**COMMITTEE OF EXPERTS ON THE TRANSPORT OF
DANGEROUS GOODS AND ON THE GLOBALLY
HARMONIZED SYSTEM OF CLASSIFICATION
AND LABELLING OF CHEMICALS**

Sub-Committee of Experts on the
Transport of Dangerous Goods

PERFORMANCE OF PACKAGINGS, INCLUDING IBCs

Puncture test for infectious substance packagings - Chapter 6.3 of the Model Regulations

Fig 1

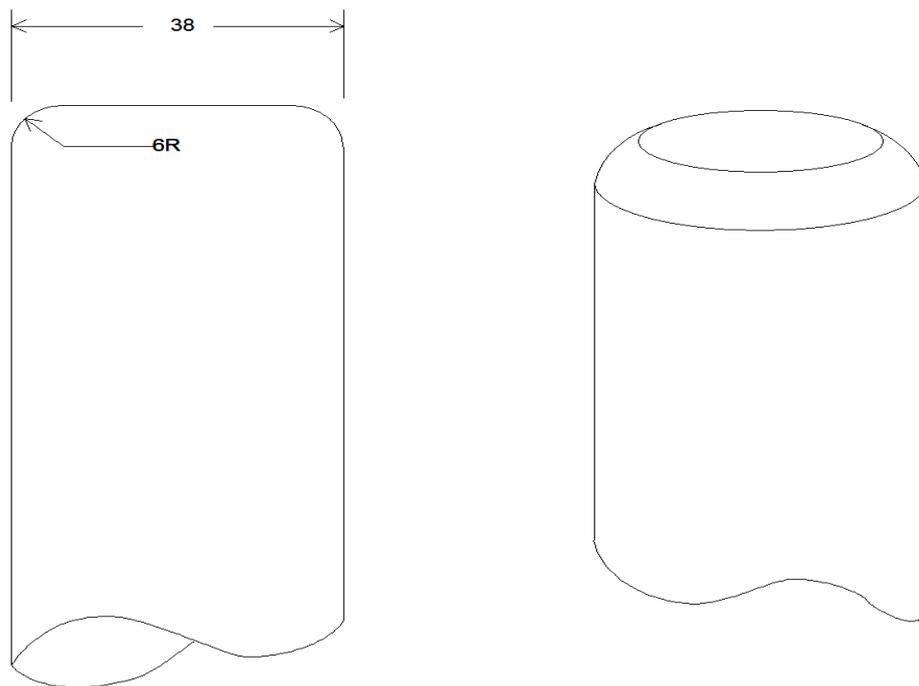
During the recent meeting of the ICAO Dangerous Goods Panel in Memphis the delegate from the People's Republic of China raised the question regarding the shape of the steel rod that should be used in the puncture test in Chapter 6.3 of the Model Regulations. This matter has been raised in the past and the wording has been amended from time to time to clarify the meaning. There is still, however some confusion remaining. The expert from the United Kingdom undertook to clarify the requirement in the Model Regulations and considers an illustration might help. The proposal below is to introduce such an illustration. There are no changes to the text.

- (a) Samples shall be placed on a level hard surface. A cylindrical steel rod with a mass of at least 7 kg, a diameter of 38 mm and the impact end edges a radius not exceeding 6 mm (see Fig 1 below), shall be dropped in a vertical free fall from a height of 1 m, measured from the impact end to the impact surface of the sample. One sample shall be placed on its base. A second sample shall be placed in an orientation perpendicular to that used for the first. In each instance the steel rod shall be aimed to impact the primary receptacle. Following each impact, penetration of the secondary packaging is acceptable, provided that there is no leakage from the primary receptacle(s);
